## SERVICE BULLETIN

ENGINE - FUEL AND CONTROL - ENGINE - PROVIDE AN ADDITIONAL WASHER ON THE HI-LOK PIN OF THE DATA ENTRY PLUG - CATEGORY CODE 6 - MOD.ENG-73-0005

V2500-ENG-73-0005

Before and after alteration of the data entry plug assembly attaching parts  
Fig.2

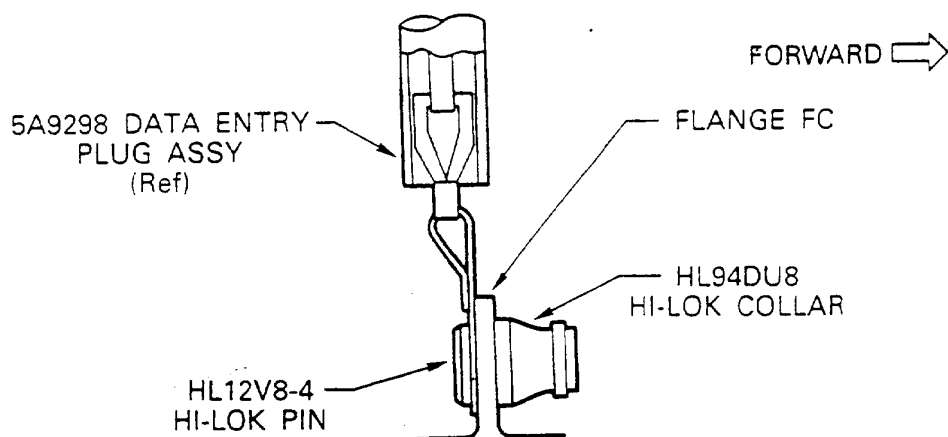
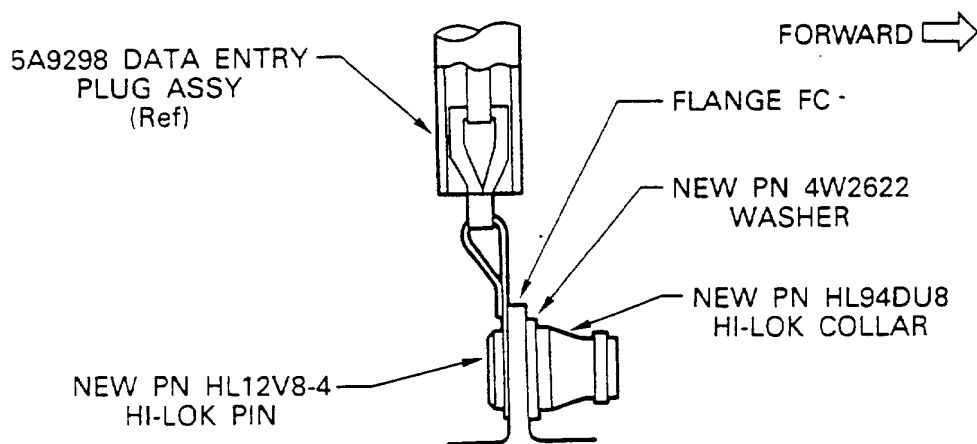
To add a washer between the Hi-Lok collar and the Flange FC to enable the Data Entry Plug Assembly to be tightened correctly.

- (a) The washer PN4W2622 is added between the Hi-Lok collar and the Flange FC (See Figures 1 and 2).

Rework of the data entry plug assembly attaching parts  
Fig.3

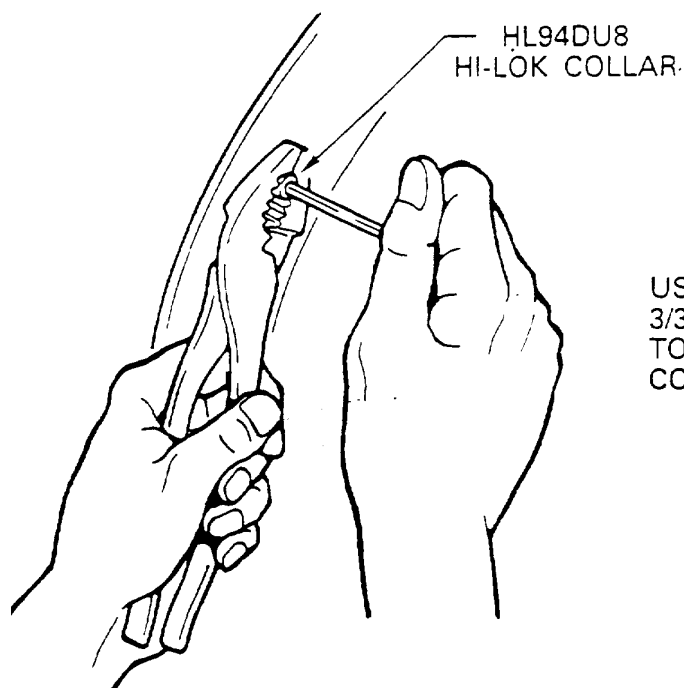
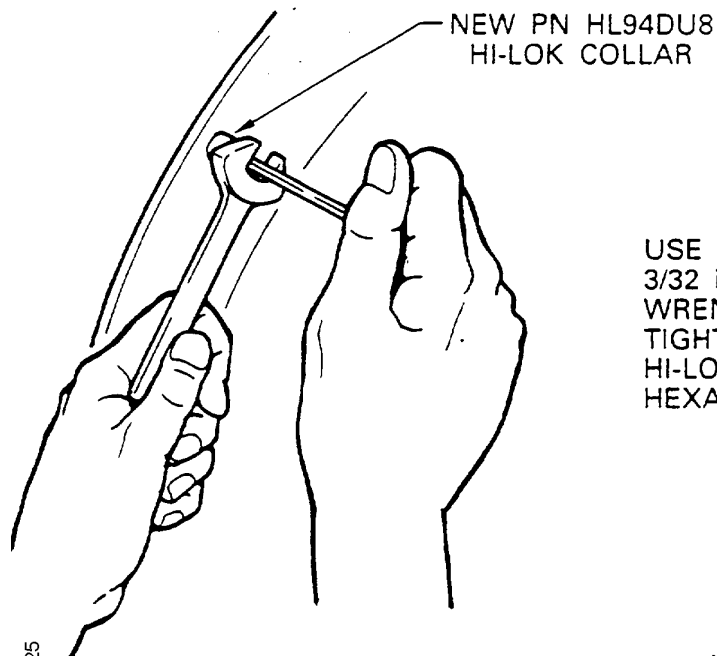
USE THE ALLEN WRENCH SIZE  $\frac{3}{32}$  in. AND THE PLIERS TO LOOSEN HL94DU8 HI-LOK COLLAR.

USE THE ALLEN WRENCH SIZE  $\frac{3}{32}$  in. AND THE OPEN-END WRENCH SIZE  $\frac{7}{16}$  in. TO TIGHTEN NEW PN HL94DU8 HI-LOK COLLAR UNTIL THE HEXAGON NUT IS SHEARED OFF.
